TECHNICAL INFO Nr. 65

Bulletin of technical information reserved for Installers and Retailers Landi Renzo

Subject: Directive to install pressure regulator LI10

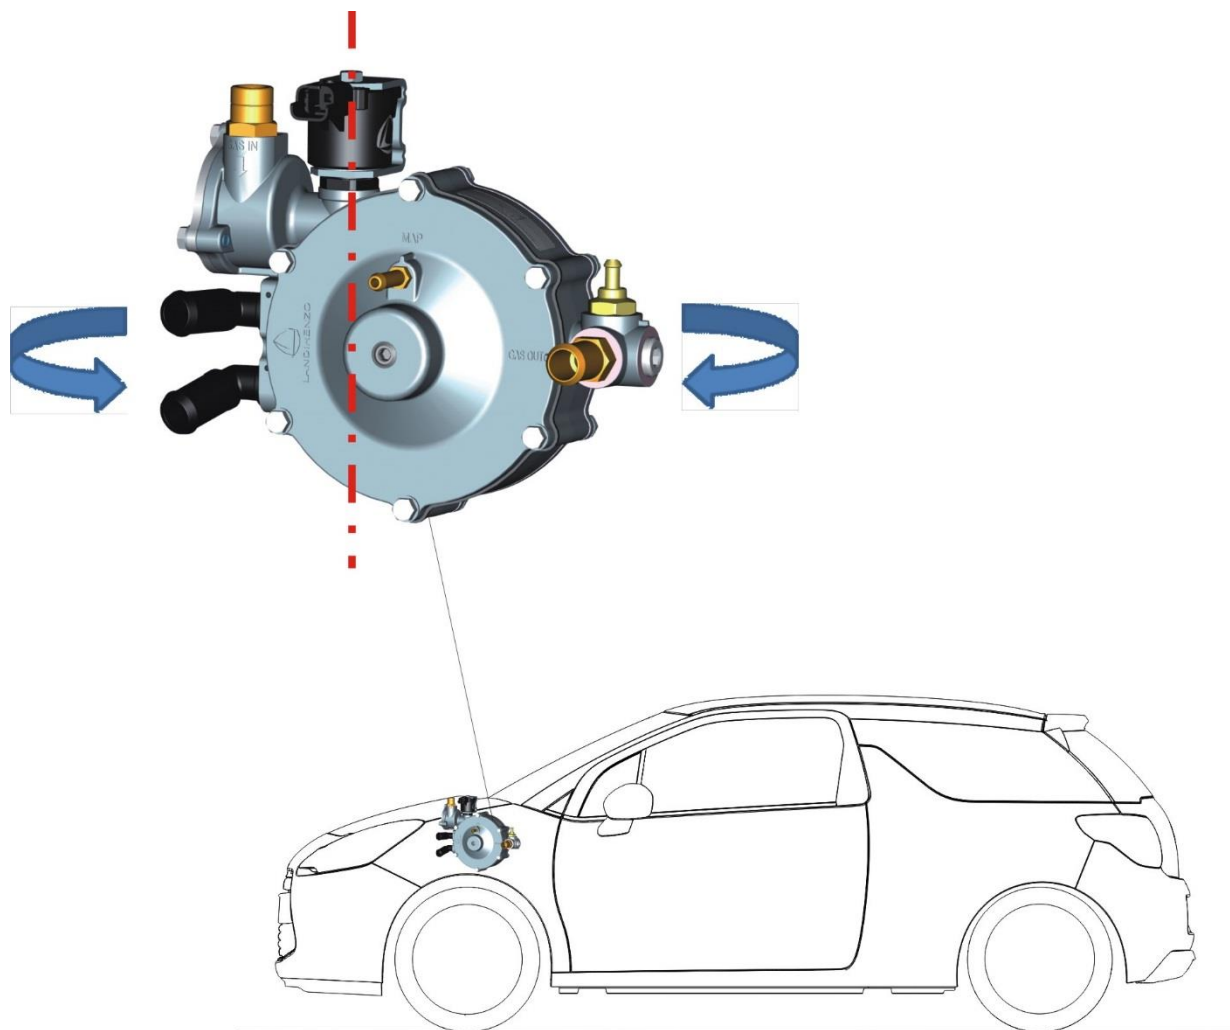
The installation of the pressure regulator LI10 must observe the following provisions:

- The axis of the solenoid valve of the regulator must be orthogonal to the ground
- The axis of the solenoid valve of the regulator must always be positioned upwards

As shown in the figure, the regulator can be rotated on the axis of the solenoid valve, but it must always be facing upwards.

This technical information integrates and replaces all the provisions of installation schemes and manuals and all new installations must follow this directive
